# Planning Scheme Amendment C339ggee Flood overlays and zones

## REVIEW OF COMPLEX SUBMISSIONS – LARA, AVALON AND FYANSFORD

City of Greater Geelong

July 2022

Figure 1 – Overview map of Lara - with overlays exhibited (blue & purple) and to be removed (red)

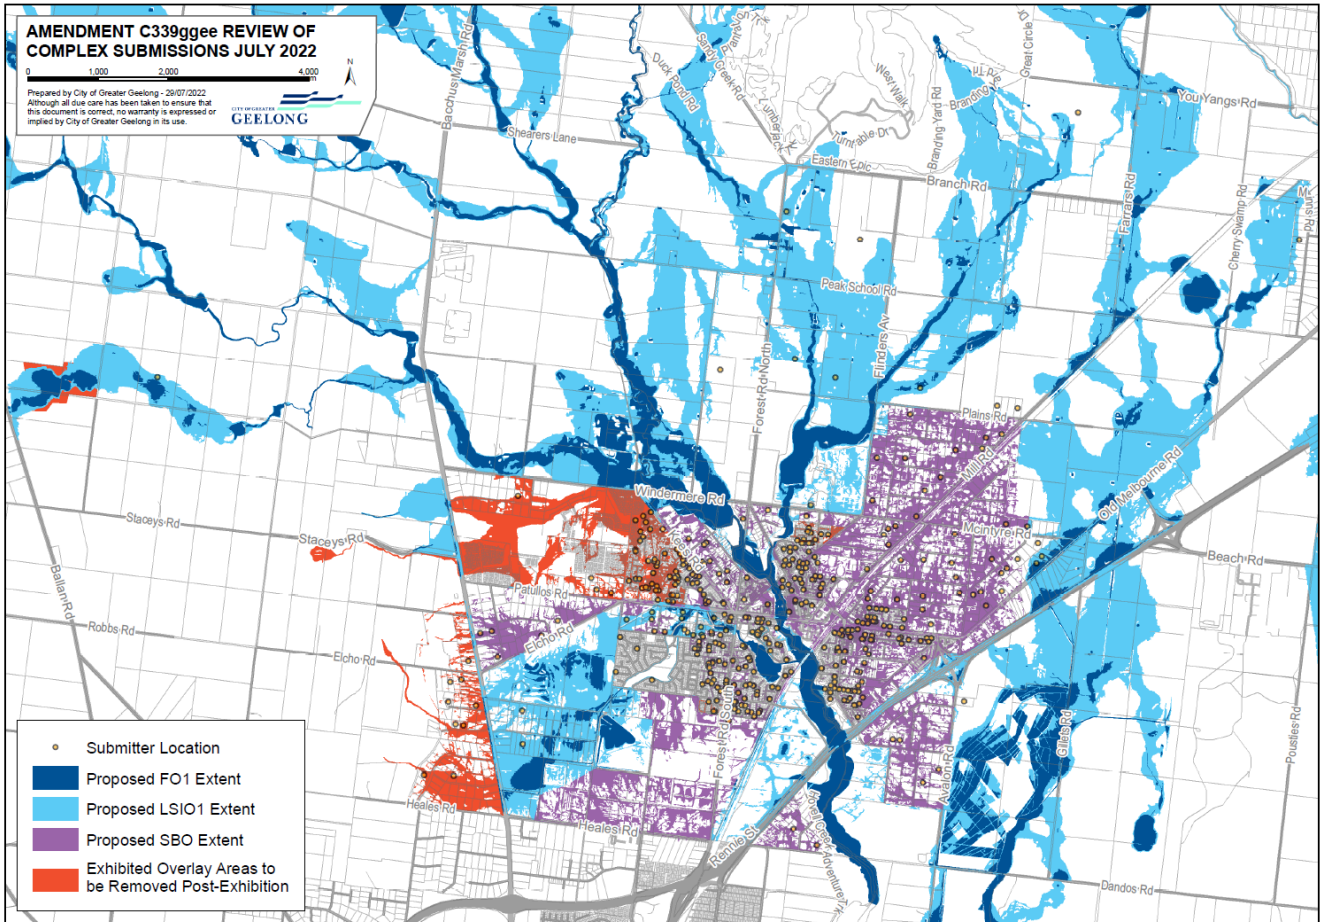
22. The maps in **Appendix 2** have been prepared showing areas in red that had overlays exhibited but which are now recommended to be removed from the amendment. An overview map of Lara showing exhibited overlays and areas to be removed is in **Figure 1** below and a larger image in Appendix 2.

23. A total of 2203 properties are proposed to be removed as detailed below:

## Map 2 - Altair Avenue Lara

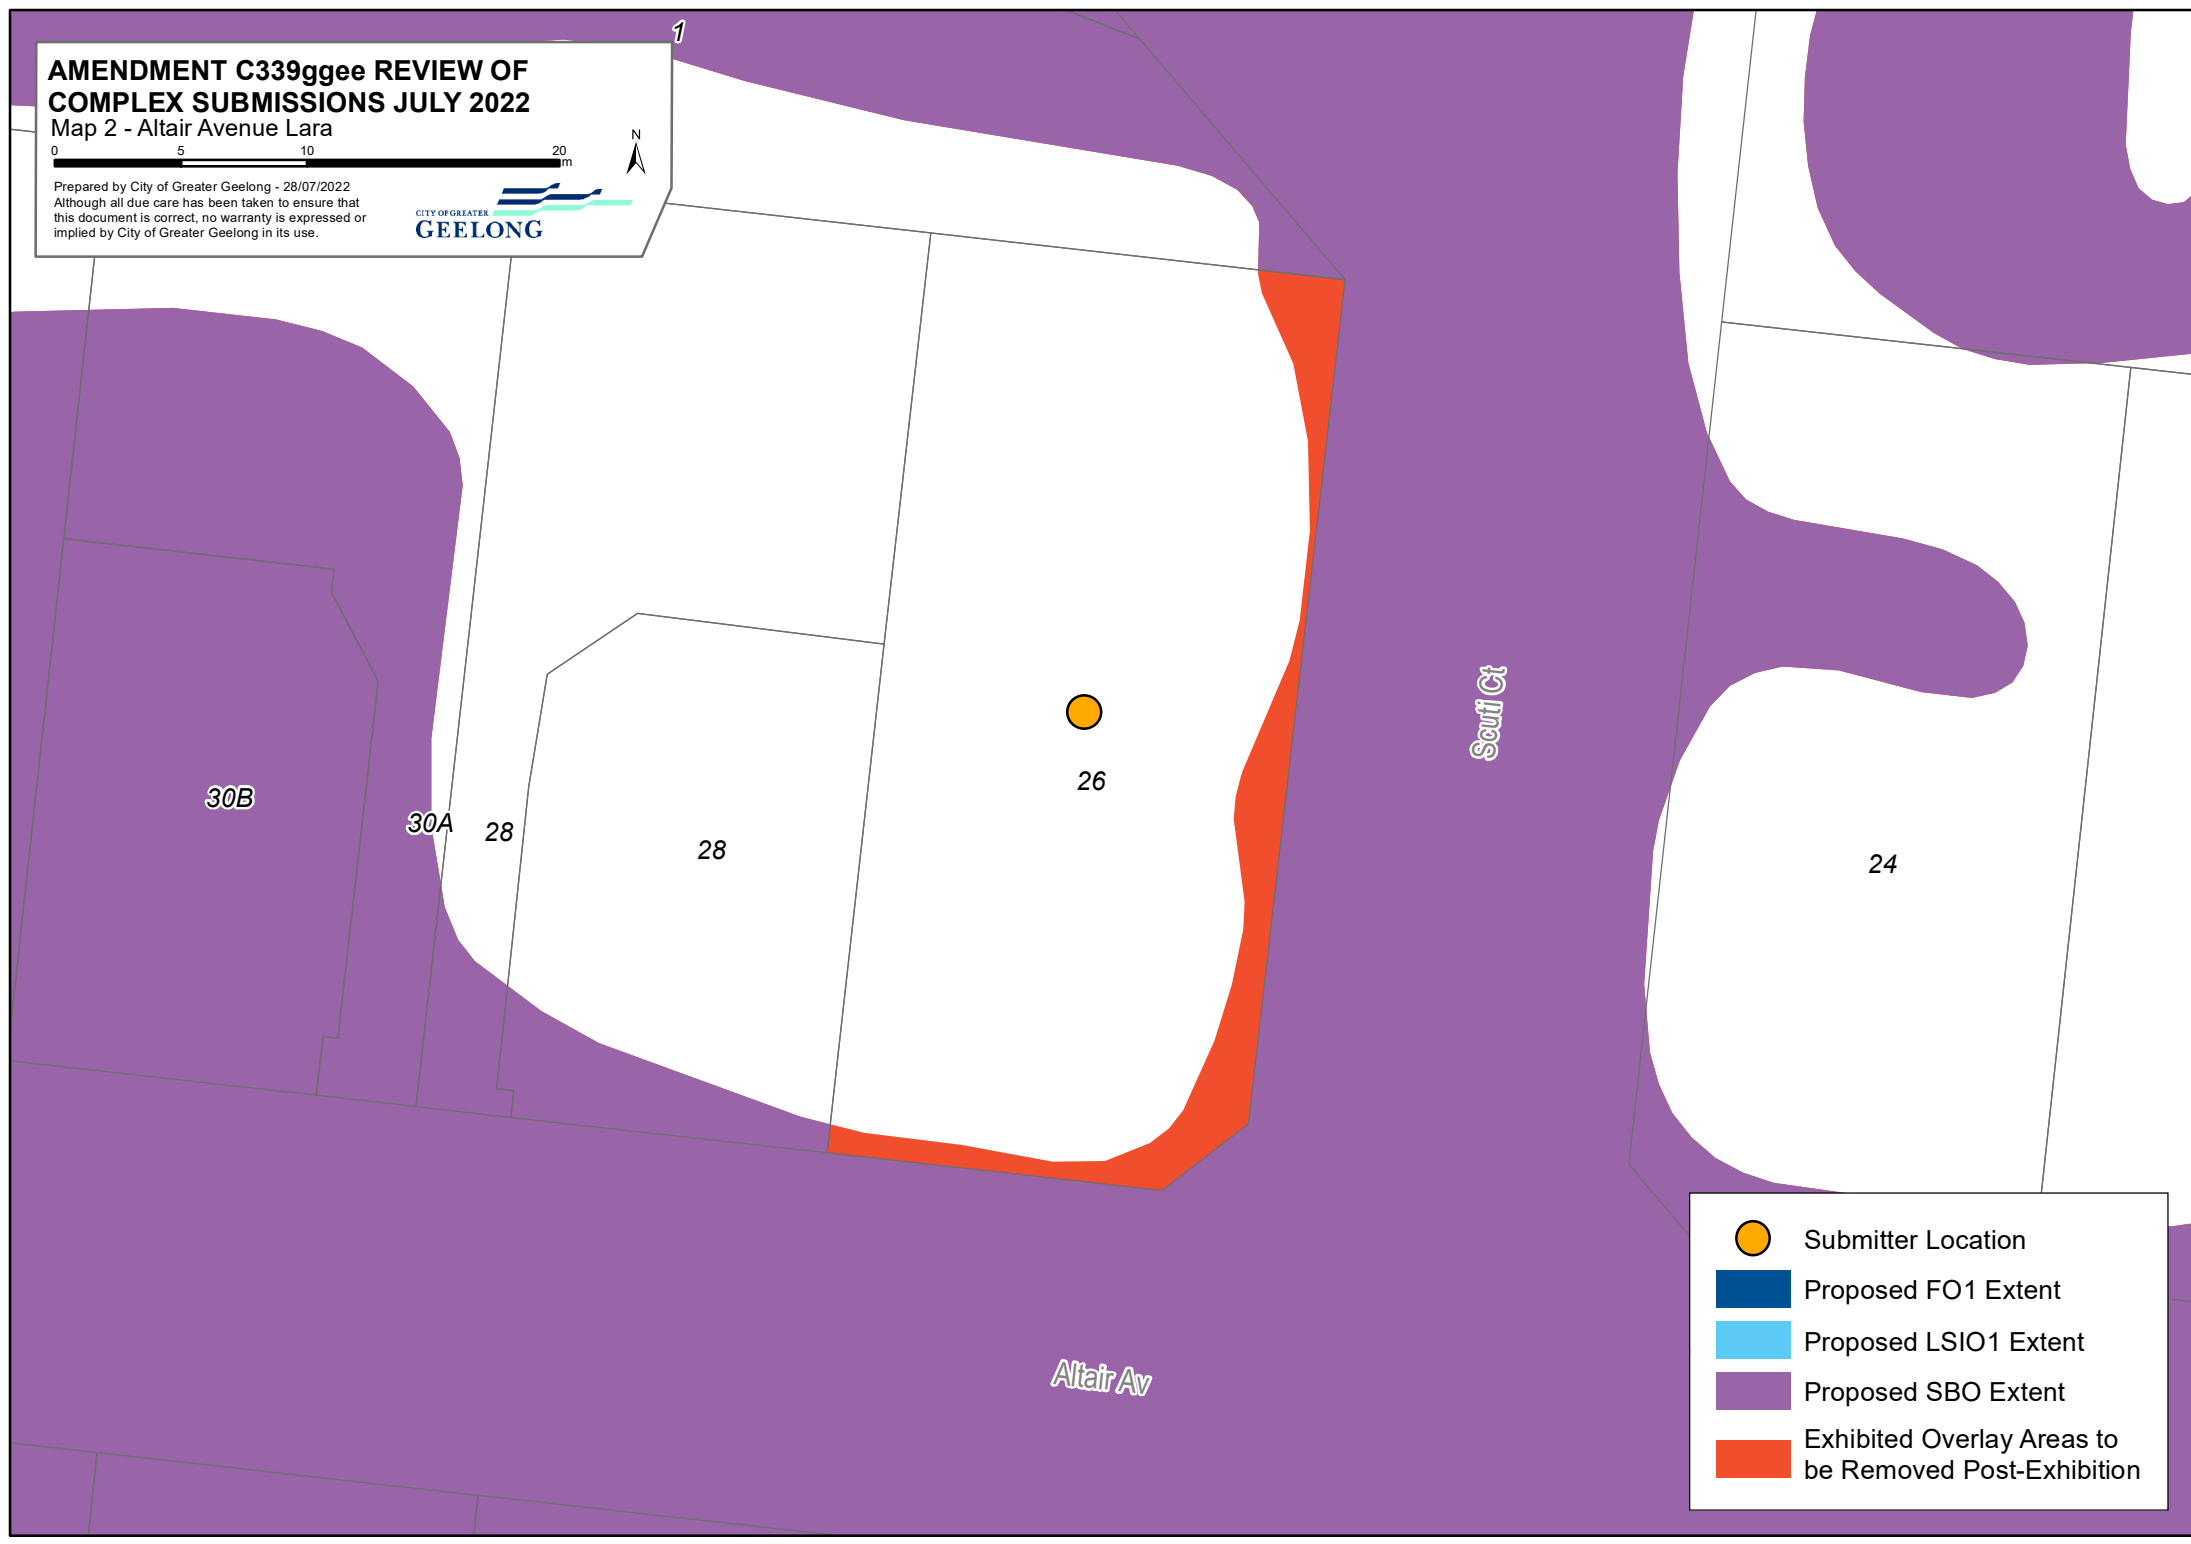
Sub No.	Surname	Property Address	Suburb (Growth Area)	Reviewed by:	Proposed Planning Control	Summary of Submission	Response	Change to maps?
							<p>submission are within the proposed SBO, which suggests results of the flood model are generally accurate.</p> <p><b>No changes are recommended.</b></p>	
334	Individual Submitter	Altair Ave	Lara	CoGG Engineering	SBO	<p>SBO only covers a small amount of property. This amendment is provisionally supported on the basis that:</p> <ol style="list-style-type: none"> <li>1. Residential properties are not publicly defined as being within a SBO if the SBO covers a minor percentage of the land or dwelling area.</li> <li>2. Additional approvals are not required for minor interior and exterior changes (e.g. fencing, replacing roofing on existing pergola) for areas of a property impacted by the SBO overlay but outside the specific SBO overlay boundary.</li> <li>3. Assistance is provided (e.g. advice, materials) to property owners to minimise any impact of storm water in advance of such occurrence.</li> </ol>	<p>It is noted the submitter generally supports the application of planning controls based on the Lara Flood Study 2020 but has some concerns relating to the need for approvals for minor works and support during flood events.</p> <p>As previously detailed, the proposed Special Building Overlay is based on the modelled 1% AEP flood extent with some minor modifications to remove shallow depths and isolated ‘puddles’ and to smooth the blocky raw model outputs. Property boundaries were not considered in this process.</p>  <p>Most of the subject property is flood free, with modelled flood depths in the proposed SBO between 0.03 – 0.06m (30 – 60mm). The need for a permit is triggered by buildings or works within the SBO, subject to exemptions listed in cl 44.05-2. For example, a replacement fence in the same location and</p>	<p>Yes, clip overlay to exclude property</p> <p>See Map 2</p>

Map 3 - The Centreway Lara

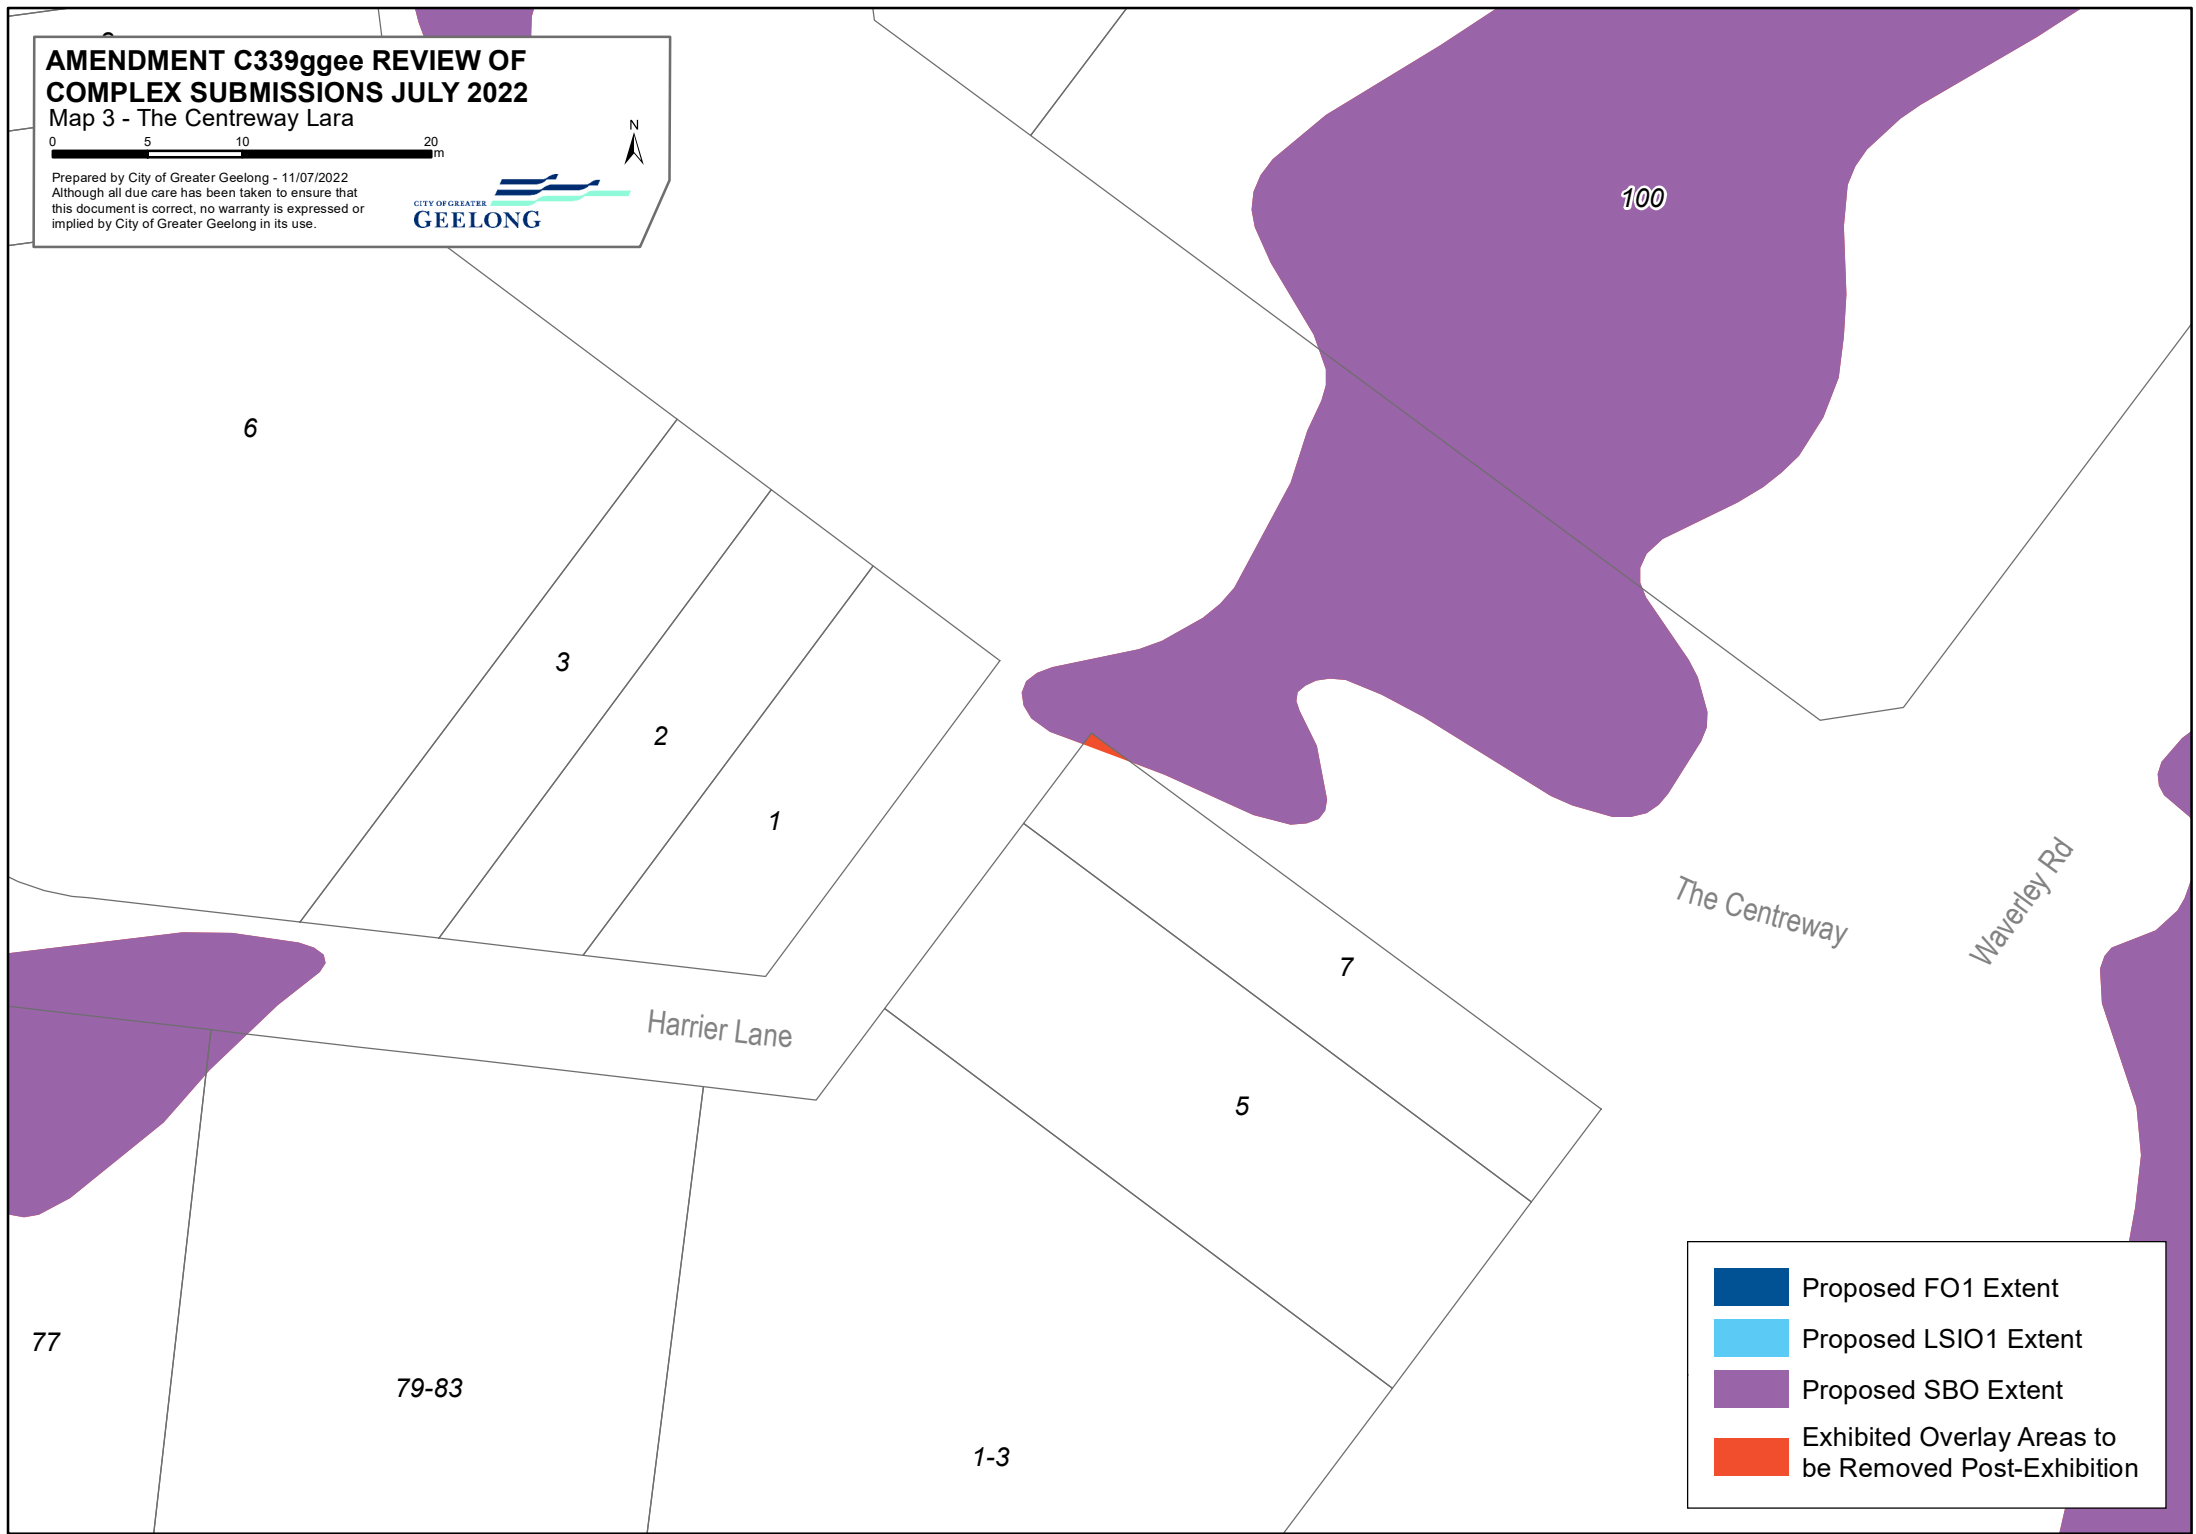
410	ROAD Securities	Grosvenor Drive	Wandana Heights	CoGG Engineering	SBO	The current floor slab is about 250mm above the existing gutter. Also cites other examples where modelling contradicts real world.	<p>This submission requests amendment of the Special Building Overlay due to minor encroachment of their property. Less than 1m2 of the property is proposed to be encumbered. Modelling outputs show the depth of water in the affected corner is 0.03m (30mm).</p> 	<p>Yes - clip overlay to exclude property</p> <p>See Map 3</p>
